TITLE: **SPECIAL PERMIT NO. 1762A, VINTAGE HEIGHTS 3RD ADDITION COMMUNITY UNIT PLAN**, requested by Engineering Design Consultants on behalf of Hampton Development Services, for approximately 946 dwelling units, with variances to the front yard setbacks, lot width and lot area, on property generally located at South 91st Street and Pine Lake Road.

P.A.S.: Vintage Heights 3rd Addition **DATE:** November 14, 2002
Annexation #02009
Change of Zone #3374
Special Permit #1762A
Preliminary Plat #02017

**ANNEXATION NO. 02009;
CHANGE OF ZONE NO. 3374,
SPECIAL PERMIT NO. 1762A,
AMENDMENT TO THE VINTAGE HEIGHTS 3RD ADDITION C.U.P.;
and
PRELIMINARY PLAT NO. 02017,
VINTAGE HEIGHTS 3RD ADDITION**

To: Becky Horner, Planning
From: Dennis Bartels, Public Works and Utilities
Subject: Allegrini Terrace at Vintage Heights 3rd Addition, Preliminary Plat and CUP
Date: October 14, 2002
cc: Randy Hoskins
Ben Higgins
Nicole Fleck-Tooze

VINTAGE HEIGHTS 3RD ADDITION PRELIMINARY PLAT #02017

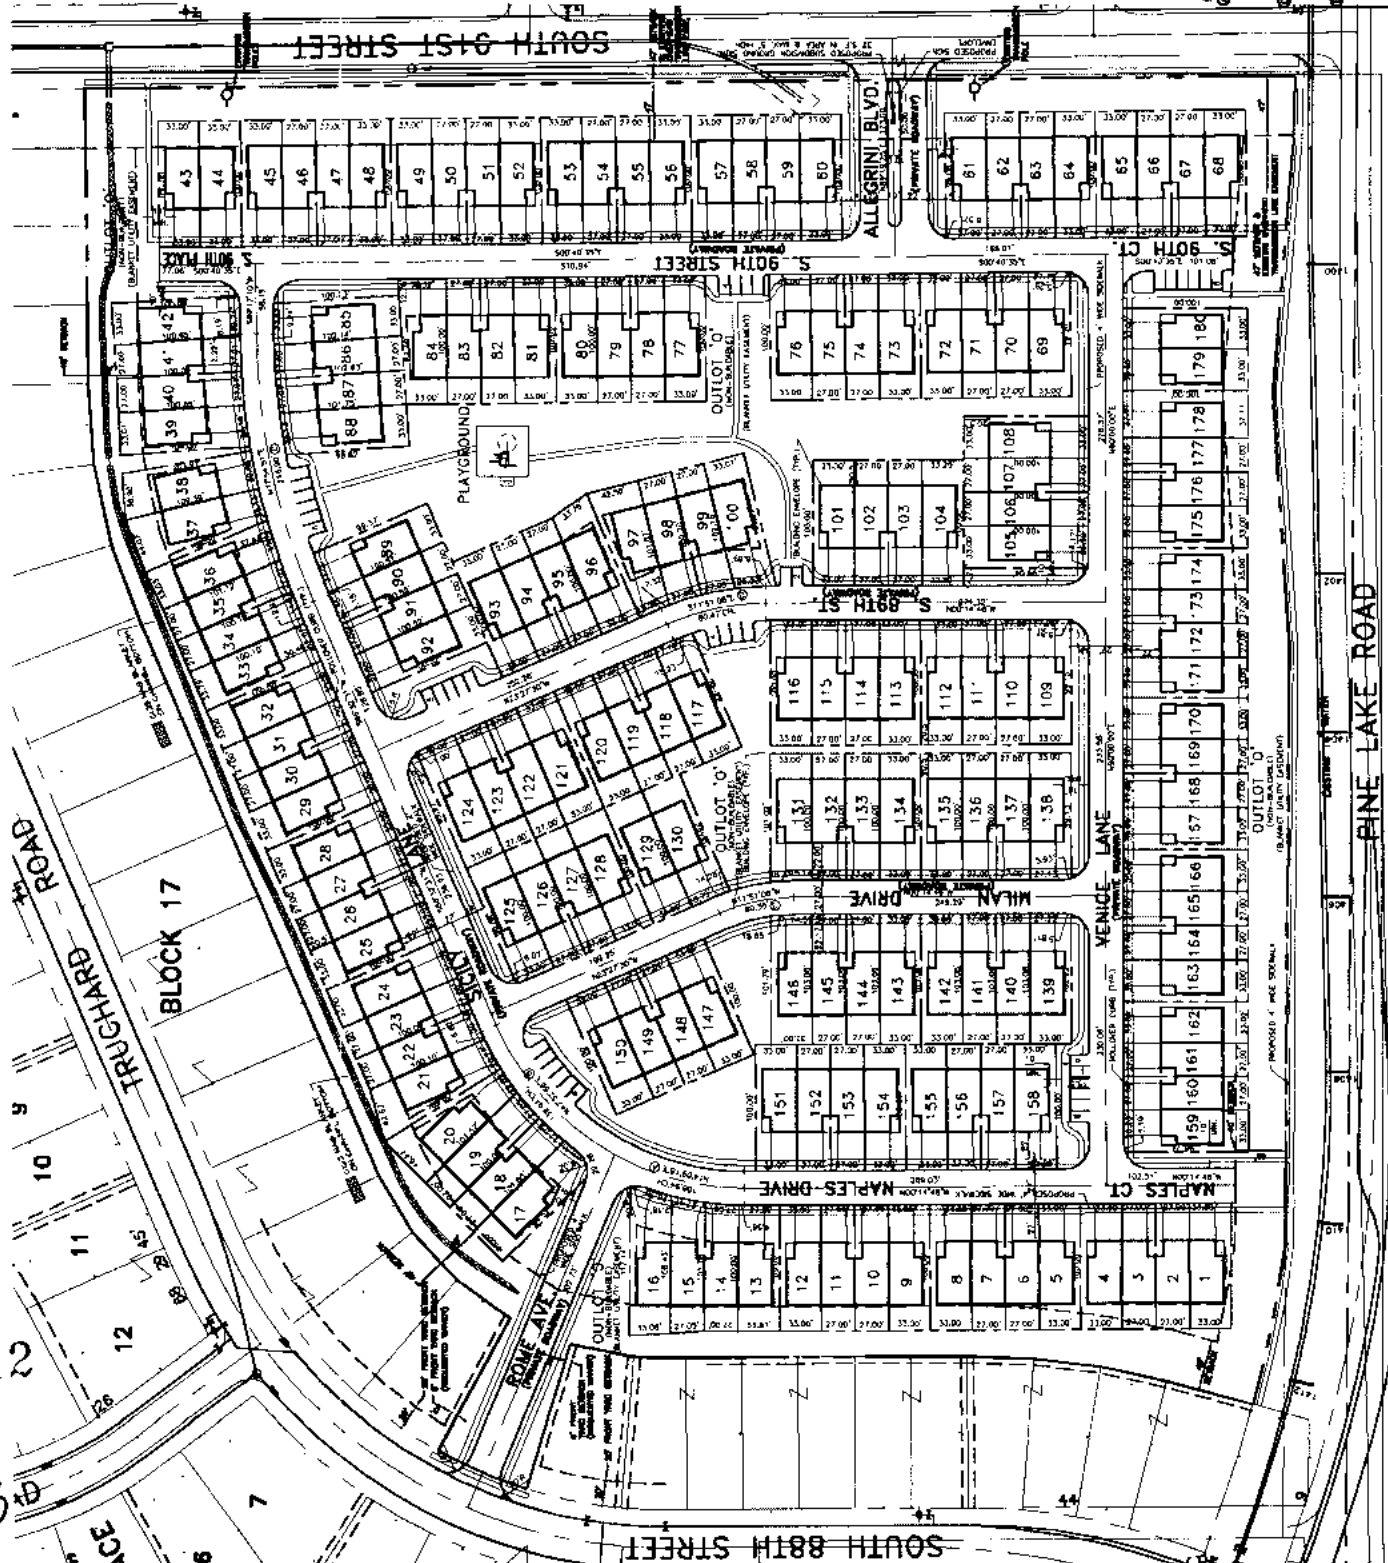
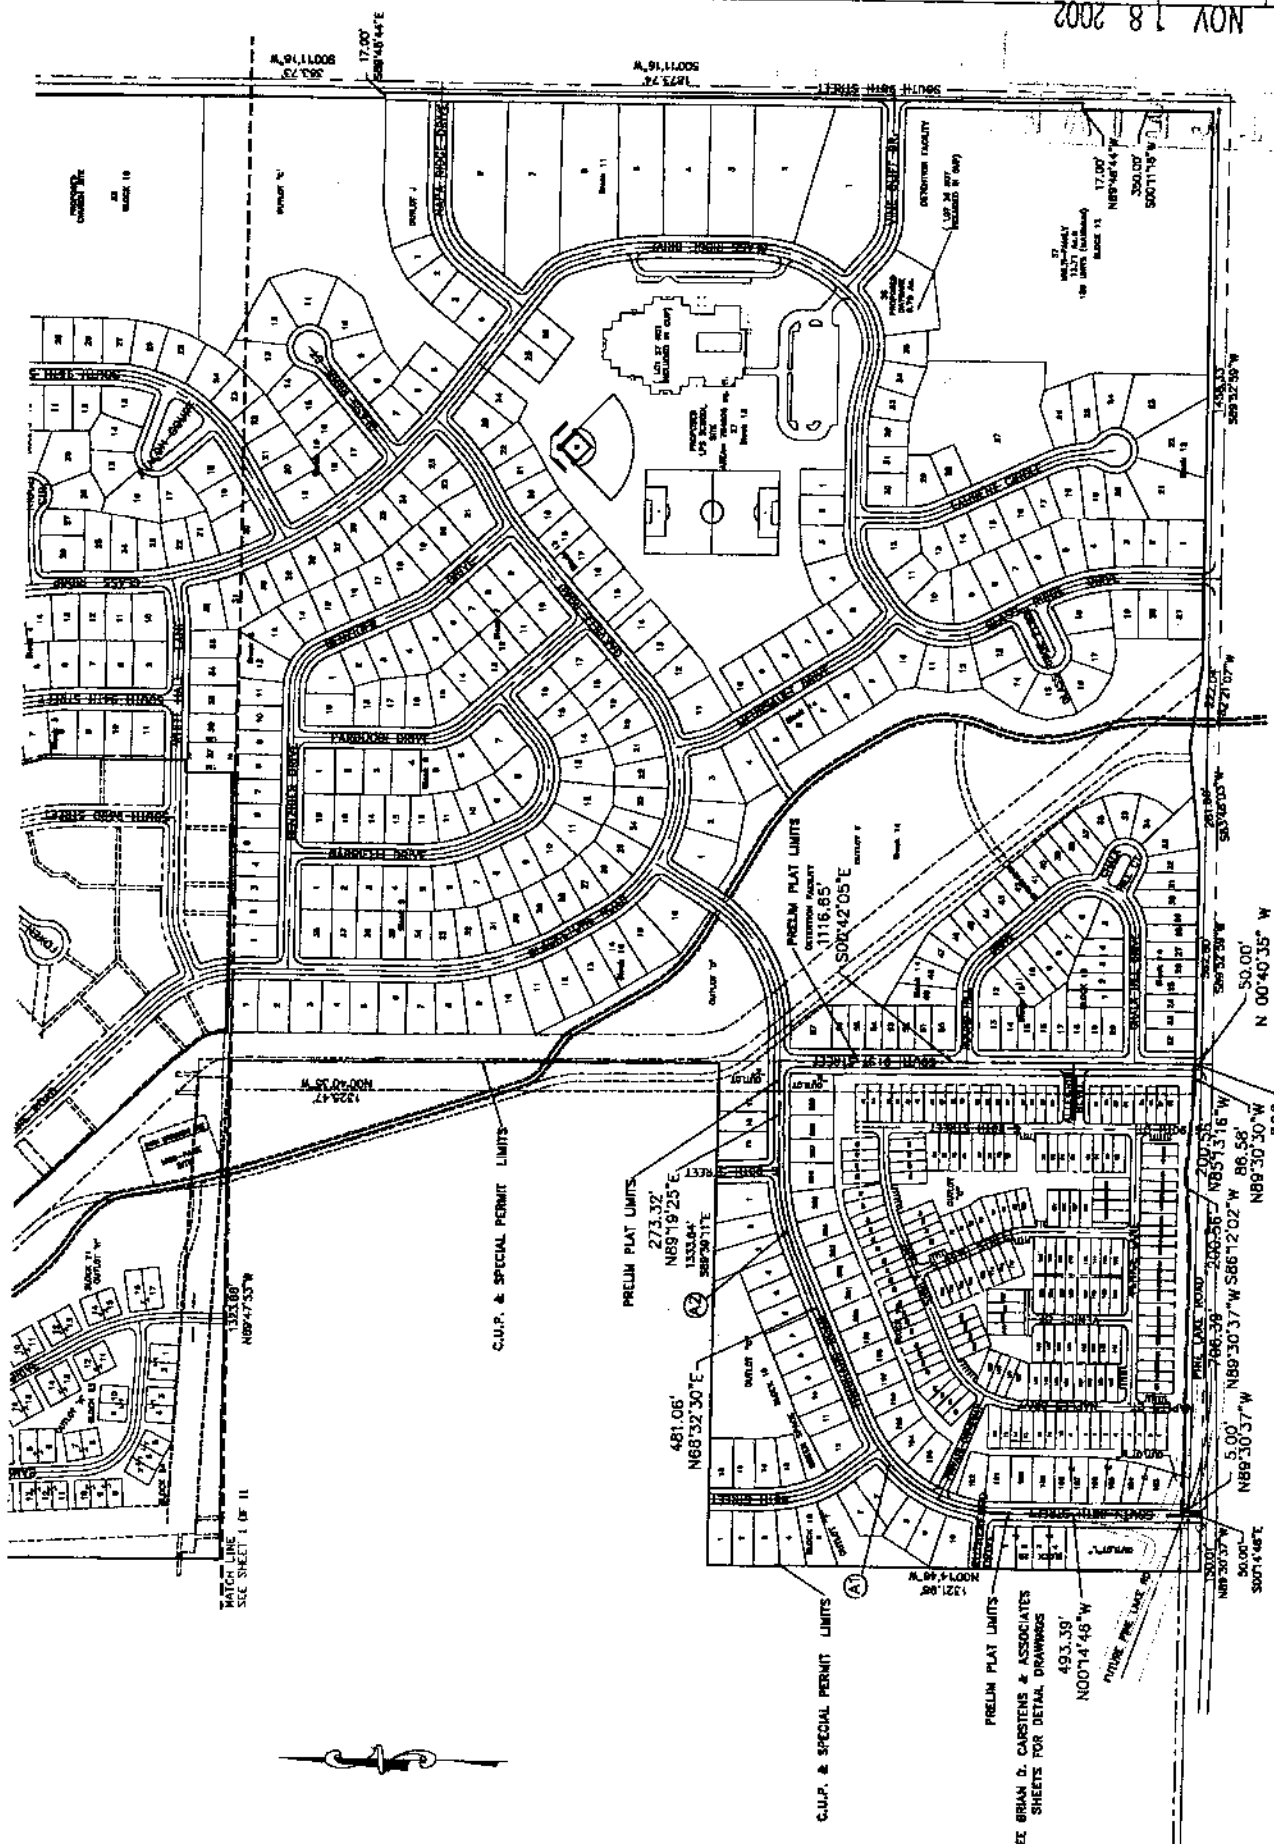
3. The Public Works & Utilities Department had the following comments:
 1. Sanitary sewer and water mains are satisfactory. The revisions to the drainage and grading plan raise an additional concern, the sanitary sewer in the northeast corner of the plat between 90th and 91st Street. The location is shown at the bottom of a drainage ditch with the required easement on the steep side slopes. This is unsatisfactory and a specific 30' easement is required for this sewer. The blanket easement is unsatisfactory.

2. The plan still shows drainage flowing from the edge of pavement to the property line rather than the property line to the pavement along Pine Lake Road as required by design standards.

3. The grading information provided in the NE corner of the plat is unsatisfactory. The plan shows grading a 30' wide swale over the storm sewer in the 91st Street right-of-way. Grading and sidewalk grades in S 91st Street will not be altered. Without the regrading of the right-of-way, it appears that lots to the north will be flooded in the 100 year event. This is unsatisfactory.

4. Design standards require low flow liners or other means to provide a stable grade or hardened bottom along open drainage channels. None are shown. The bottom of the proposed channel along the north side of the plat is adjacent to platted lots. These lots should be protected up to a 100 year storm. Opening elevations for houses must be shown for lots adjacent to the open drainage channels.

5. Public Works & Utilities Department still recommends the private driveway east of S. 88th Street be built as a private roadway. Block length requirements as well as potential traffic numbers require a private roadway with Public Works indicating there will not be a median opening in Pine Lake Road at S. 91st Street. More traffic from the townhouse area will use S. 88th Street.

6. The north-south portion of Venice Court as it intersects the east-west portion is in violation of the platform requirement and must be revised. Venice Court does not have a permanent turn around as per subdivision ordinance requirements.

7. S. 88th Street is shown with wider pavement and right-of-way per Public Works & Utilities Department comments. All improvement costs will be paid by the developer. The letter of applications speaks to objections to S. 91st Street changes. Public Works & Utilities Department has not requested changes to S. 91st Street at Pine Lake Road but was pointing out to the developer that a median opening will not likely be provided on Pine Lake Road for S. 91st Street in Vintage Heights.

1. Sewer and Water - Sanitary sewer and water mains have been revised per previous comments and are satisfactory. The revisions to the drainage and grading plan raise an additional concern, the sanitary sewer in the northeast corner of the plat between 90th and 91st. The location is shown at the bottom of a drainage ditch with the required easement on the steep side slopes. This is unsatisfactory. A specific 30' easement is required for this sewer. The blanket easement is not satisfactory.
2. Drainage and Grading - Revisions were made to the grading along Pine Lake Road but the plan still shows drainage from the edge of pavement to the property line rather than property line to the pavement.

The grading information provided in the northeast corner of the plat is unsatisfactory. The plan shows grading a 30' wide swale over the storm sewer in the 91st Street right-of-way. Grading and sidewalk grades in 91st Street will not be altered. Without the regrading of the right-of-way, it appears that lots to the north will be flooded in the 100 year event. This is unsatisfactory.

Design standards require low flow liners or other means to provide a stable grade or hardened bottom along open drainage channels. None are shown. The bottom of the proposed channel along the north side of the plat is adjacent to on-platted lots. These lots should be protected up to 100 year storm. Opening elevations for houses should be shown for lots adjacent to open drainage channels.

3. Streets - Public Works still recommends the private driveway east of 88th be built as a private roadway. Block length requirements as well as likely traffic numbers require a private roadway

The north-south portion of Venice Court as it intersects the east-west portion is in violation of the platform requirement. Venice Court does not have a permanent turn-around as per subdivision ordinance requirements.

88th Street is shown a wider pavement and right-of-way per Public Works comment. The letter of application speaks to objections to 91st Street changes. Public Works has not requested changes to 91st at Pine Lake Road but was pointing out to the developer that a median opening will likely not be provided on Pine Lake Road for 91st Street in Vintage Heights.

1. (See Engineering Design Consultants response letter)
2. The water mains in South 90th Street and Naples Court are shown extended South to the 16" water main in Pine Lake Road.

3. The sanitary sewer in South 90th Street and Naples Court are shown extended South into the right-of-way of Pine Lake Road and terminated with a manhole.

5. Lyle Loth of E.S.P. has reviewed the storm water issues from Public Works. The grading plan has been modified to show additional information.
6. See note #5 above.

7. Venice Court has been modified to a pavement width of 27 feet on the piece running north/south. The hammerhead of Venice Court is shown with 21 feet wide pavement since there are only 4 units that access the roadway.

8. We have not changed the drawings as requested. After discussions with Bob Hampton, the median at South 91st Street and Pine Lake Road is not acceptable. The location of South 91st Street, a collector street, was decided at the time of the Vintage Heights Preliminary Plat approval. Adjacent residential land uses were determined at that time. South 88th Street has been widened as requested.

22. The references to side yard, back yard and front yard has been removed from all designations to setbacks.
23. The lots between South 90th Street and South 91st Street are shown fronting South 90th Street due to the fact of the transmission lines along South 91st Street. It would not be logical to force 66' driveways under the existing transmission lines. Apartments were originally envisioned along South 91st Street, we feel 4-plex units are more in scale with the duplexes on the east side of South 91st Street.
